Technical Service Bulletin

2016 CX50 FWE Cylinders
TSB00117

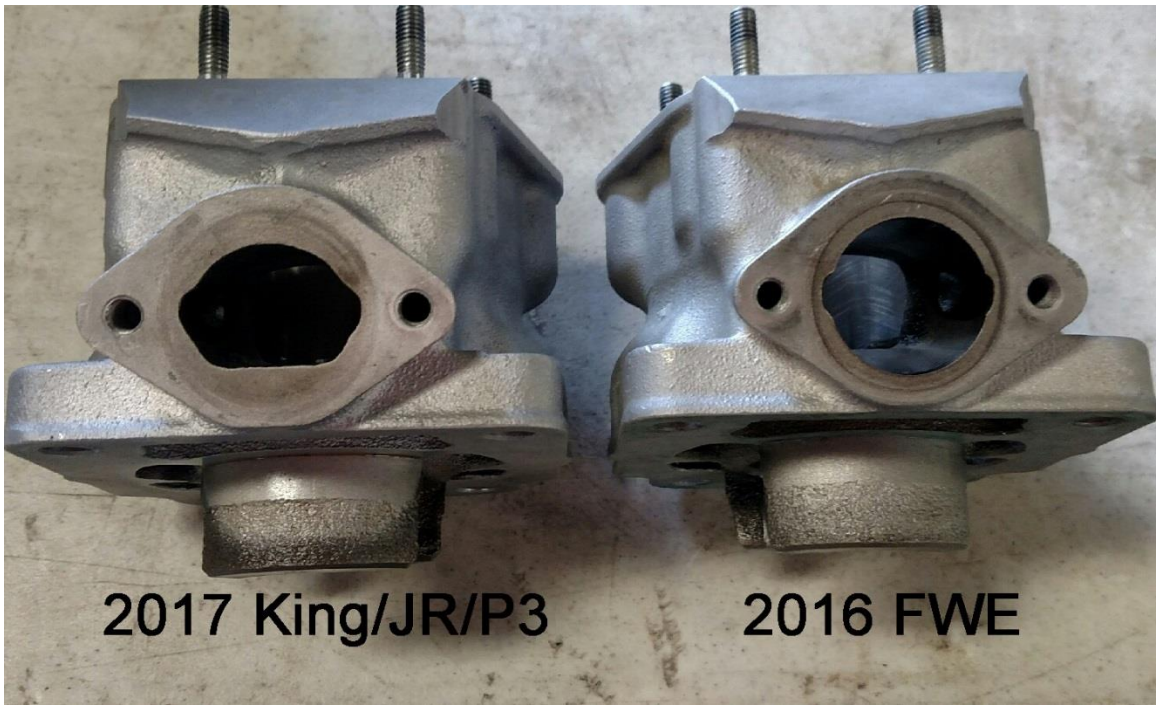
The cylinder with machined exhaust port for the 2016 Factory Works Edition CX50 has been replaced by the 2017 CX50 King cylinder which has no machining done to them. They perform identically on the dyno.

The part number remains ECMU0261
